Conway Planning Commission Staff Report

7:00pm • May 20, 2019 • 810 Parkway Avenue

REQUEST FOR PRELIMINARY PLAT APPROVAL OF PINTAIL COVE

REQUEST FOR PRELIMINARY PLAT APPROVAL OF SYLVIA SPRINGS

CITY OF CONWAY PLANNING & DEVELOPMENT DEPARTMENT PINTAIL COVE PRELIMINARY PLAT

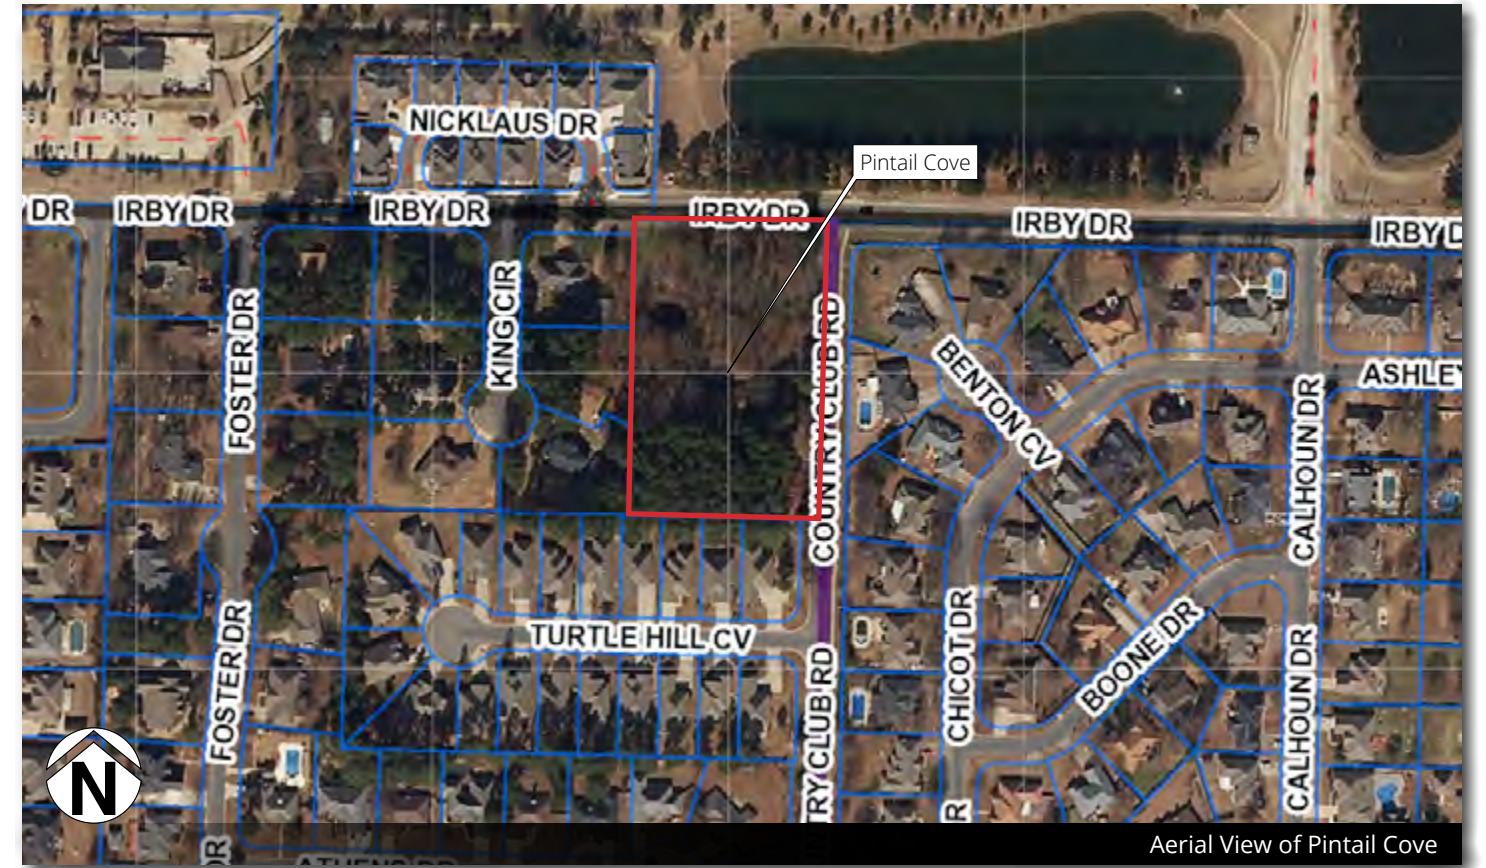
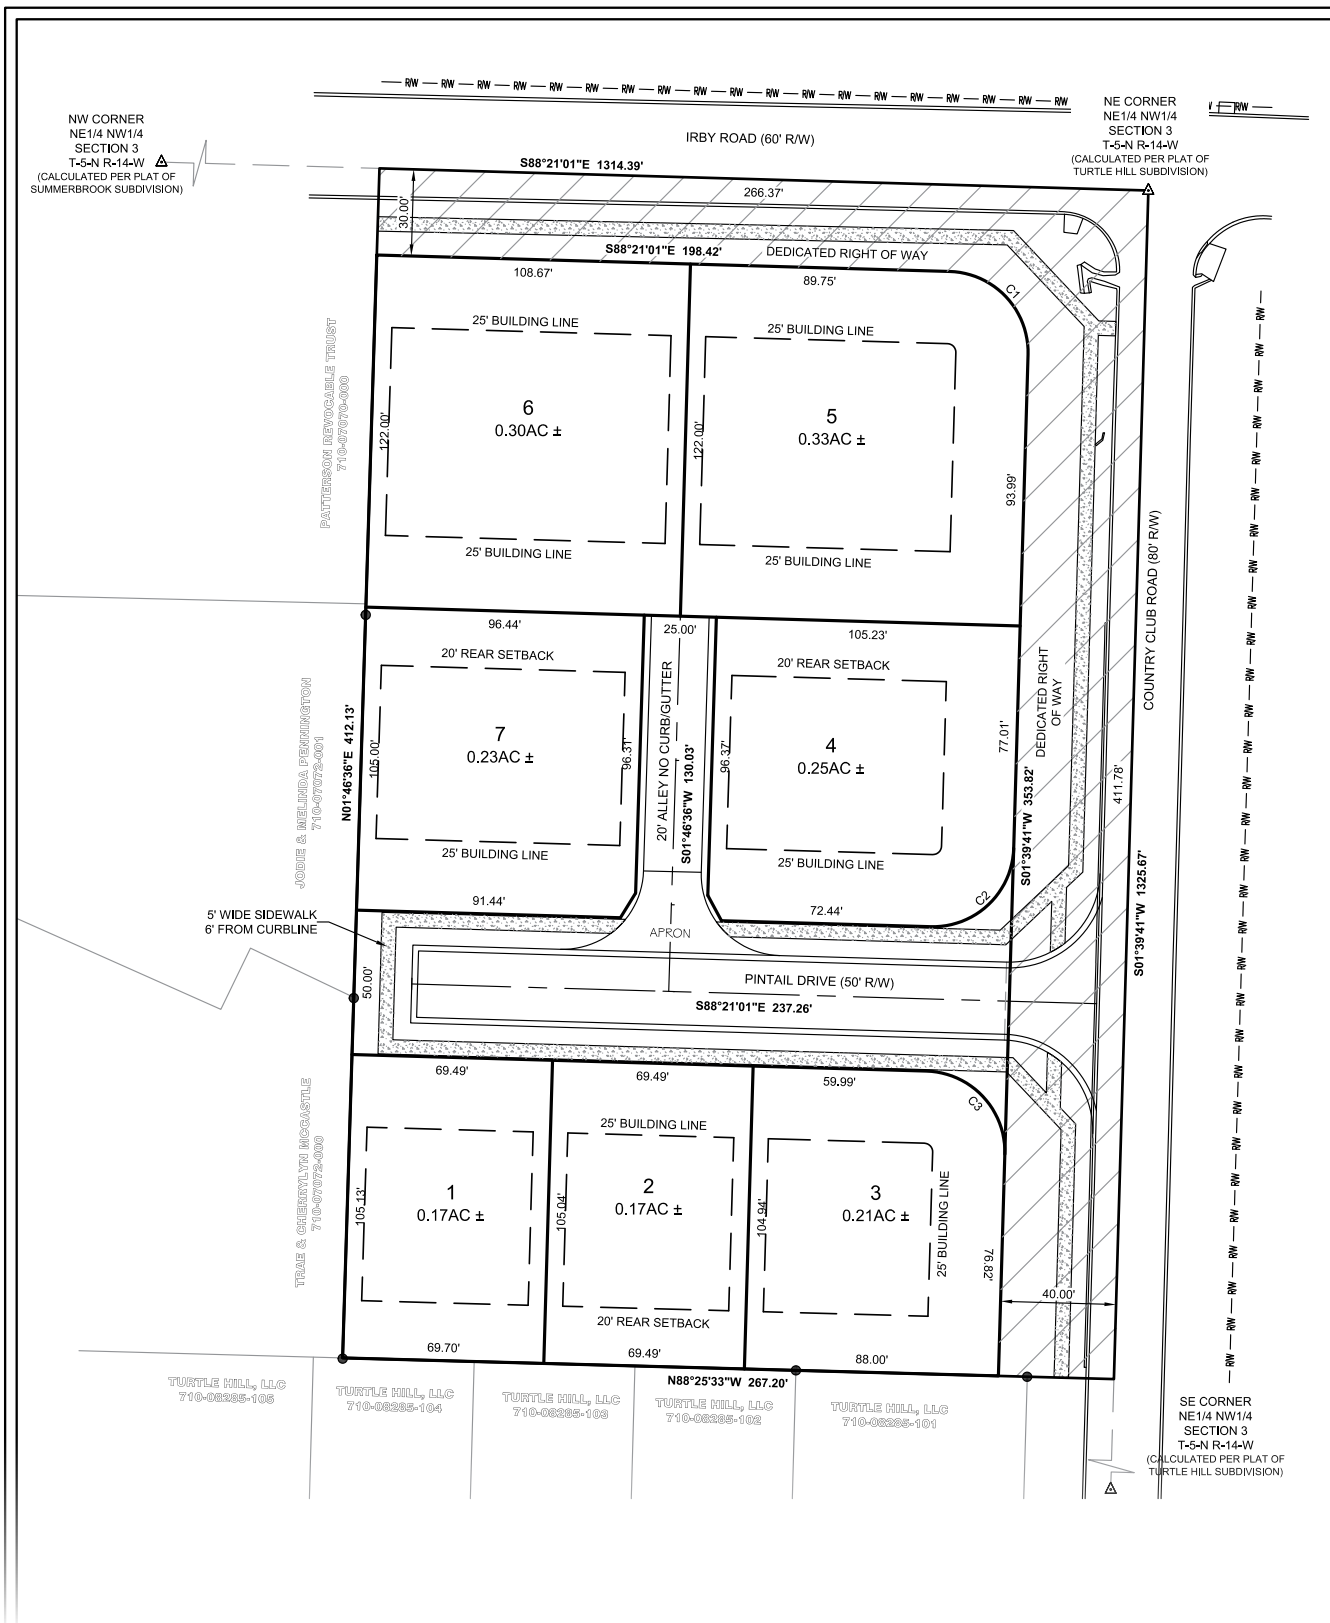
- Staff notes that lots 5 and 6 will have frontage on Irby Drive, however will be accessed by an alley to the south. Staff recommends The Commission require that a note be placed on the plat requiring the front façade of any residential units for lots 5 and 6 be oriented to Irby Drive and a planting easement provided between the units and Irby Drive.

- Remove setbacks from plat.
- Show all hydrant locations.
- Add the following to general notes:
 - Every lot must slope to a street or drainage easement.
 - (A statement indicating the ratio error closure of the field work is needed.)

Staff recommends a note be placed on the plat requiring the front façade of any residential units for lots 5 and 6 be oriented to Irby Drive and a planting easement provided between the units and Irby Drive.

CITY OF CONWAY PLANNING & DEVELOPMENT DEPARTMENT SYLVIA SPRINGS

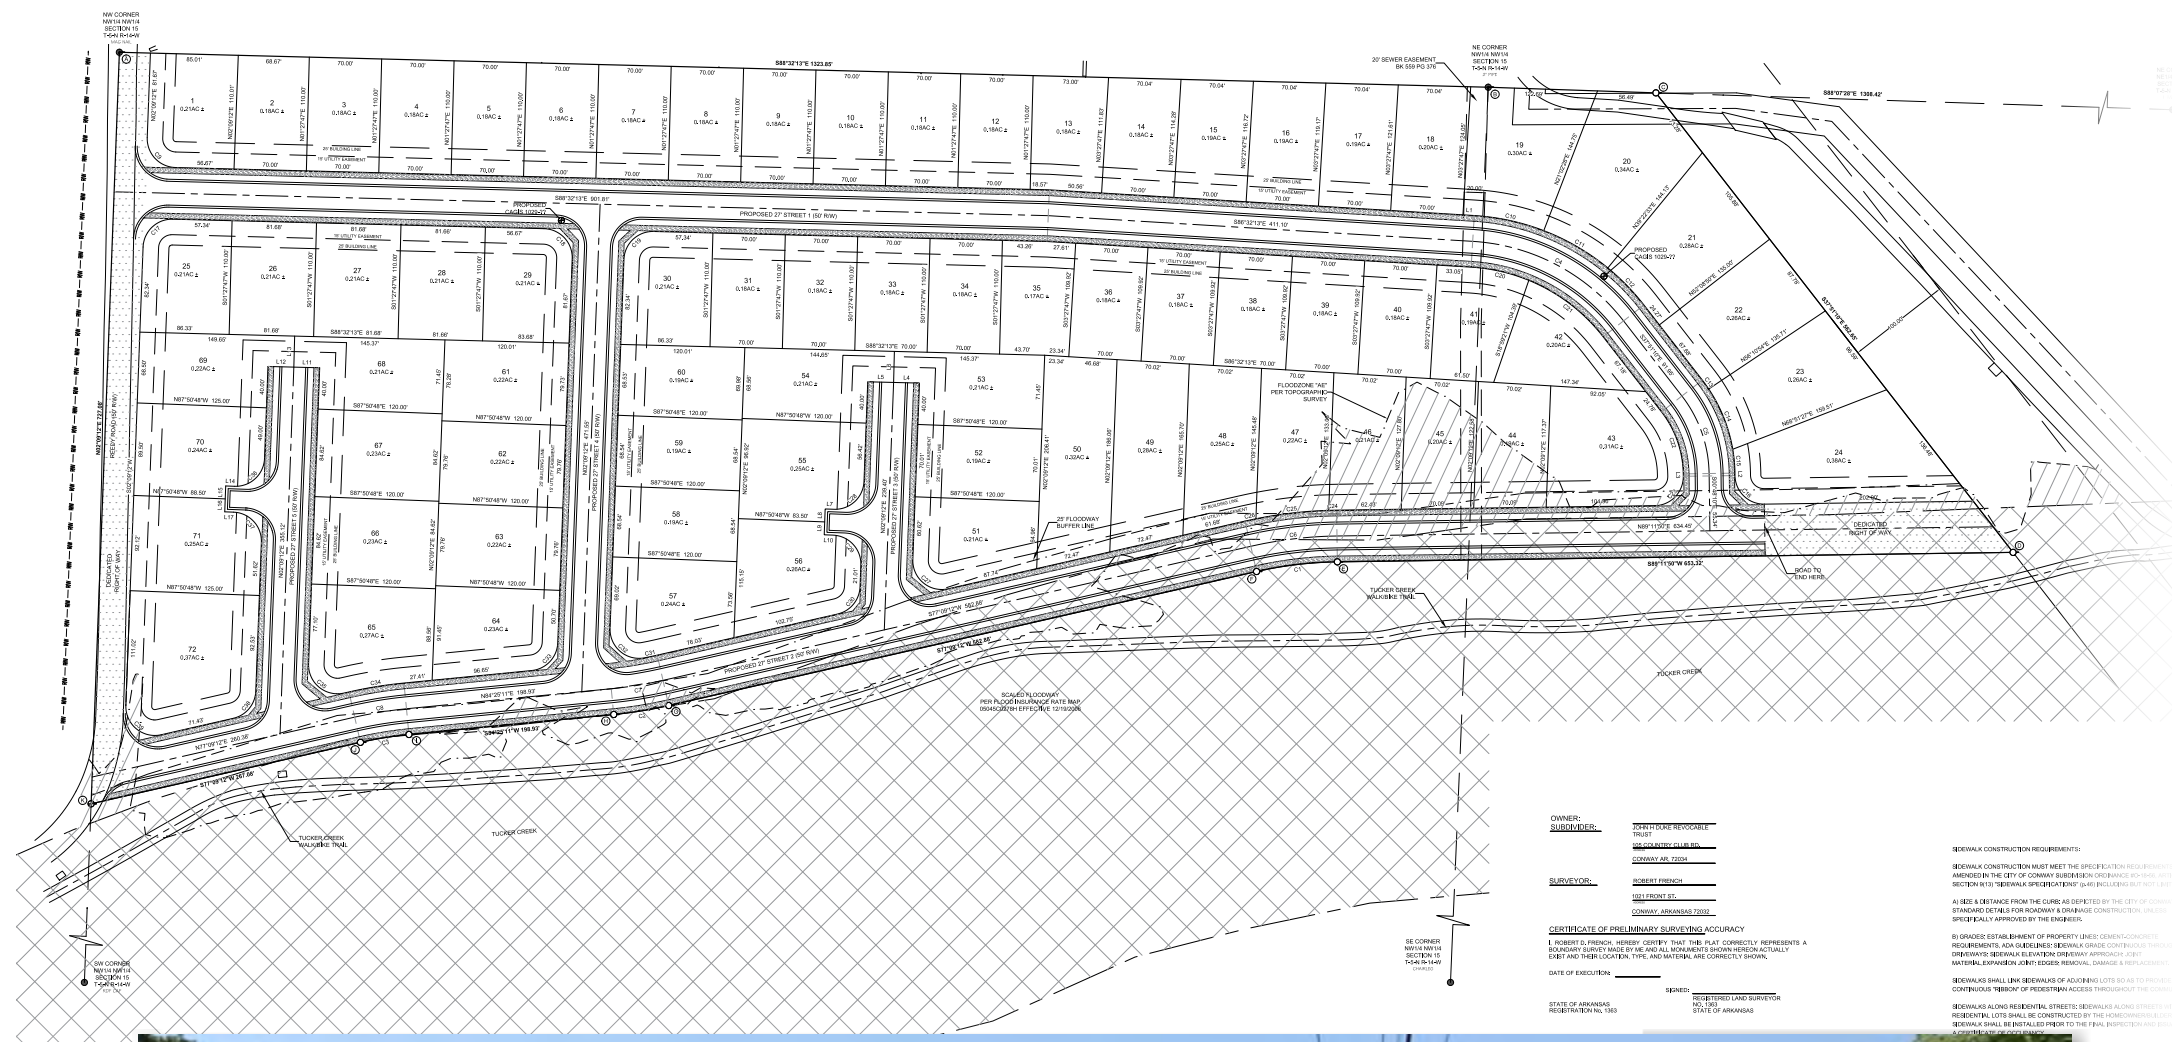
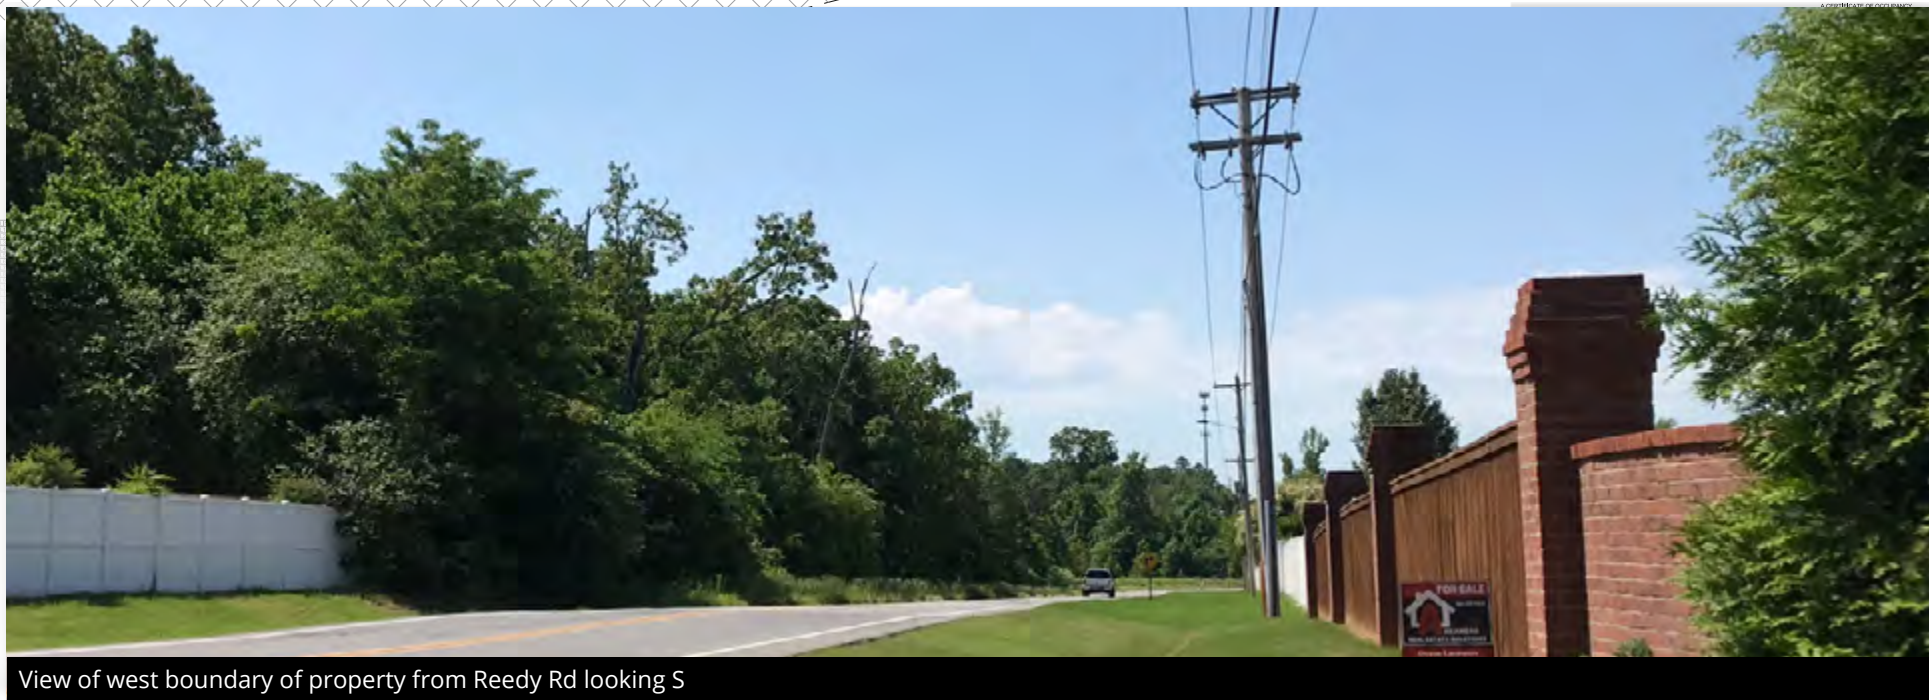
As shown, the applicant is not completing two north/south street connections. Article IV: Sec. 5(A)(2) of the Subdivision Regulations states that the proposed street layout should be appropriate for the type of development proposed and integrated with the street system in the adjoining subdivisions. The applicant has agreed to complete the street connection on the revised preliminary plat. Staff has included a recommended condition of approval requiring the connections.

1. Correct Street connections.
2. Show all hydrant locations.
3. Label and dimension required sidewalks along Reedy Road.

4. Provide appropriate ROW dedication for Tucker Creek Trail.
5. Set two new CAGIS monuments.
6. Provide planting easement or wall for lots 69-72 and lot 25.
7. Provide pedestrian connections to Tucker Creek Trail at intersections.
8. Provide connection to the Tucker Creek Trail to the north of the site.

Staff recommends a condition of approval that all street connections be completed and constructed to the property boundary.

1. Preliminary Plat approval from all reviewing agencies shall be obtained.
2. All proposed north/south streets shall make complete connections to the proposed east/west streets. No cul-de-sacs or turnarounds shall be shown on the revised preliminary plat.
